Vogtle Electric Generating Plant
Request to Change Licensed Maximum Power Level

Enclosure 1
Vogtle Electric Generating Plant
Request to Change Licensed Maximum Power Level
Description and Justification for Change

**Vogtle Electric Generating Plant
Request to Change Licensed Maximum Power Level
Marked-Up Operating Licenses, Technical Specifications, and Bases Pages**

Table 3.3.1-1 (page 5 of 9)
Reactor Trip System Instrumentation

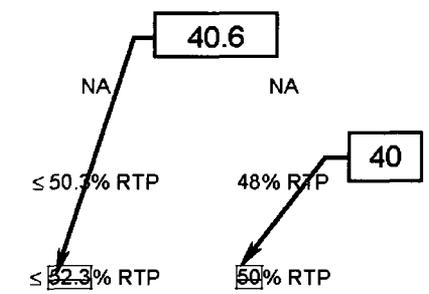
The P-9 nominal setpoint in Technical Specification Table 3.3.1-1 is being revised to 40% RTP and the Allowable Value is being revised to 40.6% RTP.
